# PEDESTRIAN SAFETY AUDIT REPORT

SR 424/Edgewater Drive from  
SR 423/Lee Road to SR 434/Forest City Road

October 2012

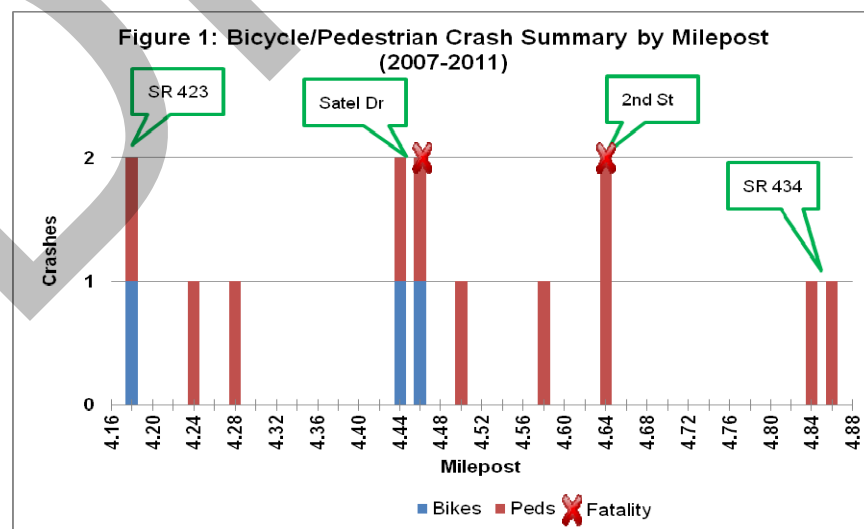
The crashes are summarized by milepost in Figure 1. As illustrated in Figure 1, eight of the 14 crashes occurred mid-block between SR 423/Lee Road and SR 434/Forrest City Road. Of the two crashes that occurred at the SR 423/Lee Road intersection, one involved a bicycle. One of the two crashes that occurred at SR 434 involved a motorized wheelchair. The crash diagram, along with other pertinent crash data and intersection signal timing data, is provided in the Appendix.

As depicted in Figure 1, over one third of the pedestrian and bicycle crashes along the study corridor occurred between Milepost 4.440 and 4.520, near Satel Drive and Aloha Street. Several factors contribute to the higher pedestrian activity in the area and, consequently, the concentration of crashes. This particular area has a residential development located to the west of SR 424 and a restaurant/nightclub/bar on the east of SR 424. In addition to the interaction between the residential and restaurant land uses, a transit stop is located approximately midway between Aloha Street and Annandale Avenue. The Pedestrian RSA team also observed a pedestrian stumble and fall within the two-way left-turn lane. The pedestrian then laid down in the two-way left-turn lane until passing motorists and law enforcement stopped and helped him to safety.

As depicted in Figure 1, two crashes occurred near 2<sup>nd</sup> Street. One of the two crashes occurred in low light conditions. The commercial land uses on the east side of SR 424 near this location are set back further from the roadway than in other places along the corridor resulting in the lower availability of ambient lighting. There are also two Lynx transit stops near this location which contribute to a higher level of mid-block crossing at this location.

**Location: Corridor Wide**

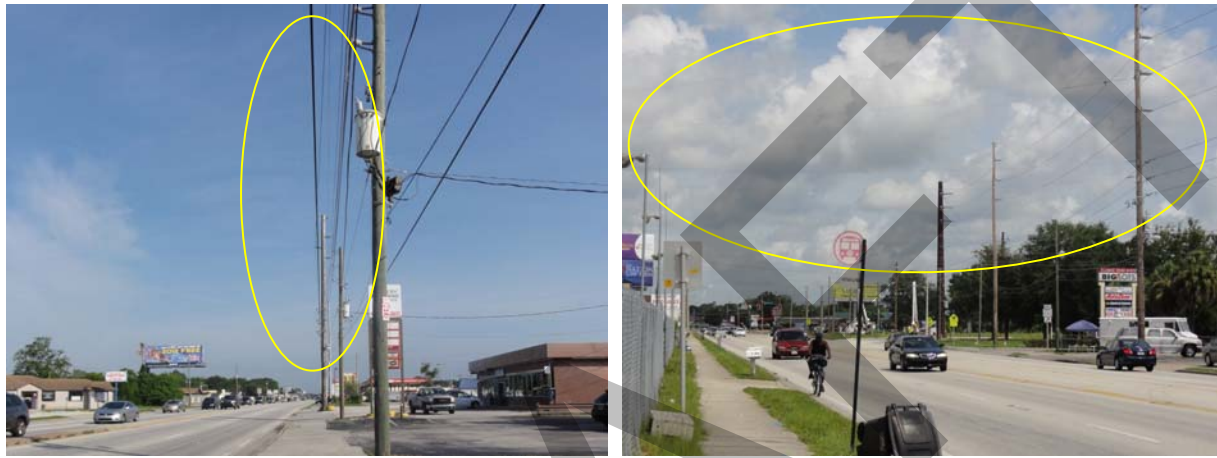
### Issue: Absence of Roadway Lighting

The study corridor does not have street lighting. The 2010 Highway Safety Manual, 1<sup>st</sup> Edition (HSM), provides an equation for crash modification factors (CMF) of roadways with street lighting. The CMF equation is:

Six of the 14 total crashes occurred at night ( $p_{nr} = 6/14 = 0.429$ ). All of the six nighttime crashes involved a fatality or injury ( $p_{inr} = 6/6 = 1.000$ ). None of the six nighttime crashes involved property damage only ( $p_{pnr} = 0/6 = 0.000$ ). Therefore, per the 2010 HSM, the crash modification factor (CMF) associated with implementing street lighting on this roadway would be 0.88. This indicates a 12-percent reduction in total crashes expected along the corridor.

Install street lighting along the corridor.
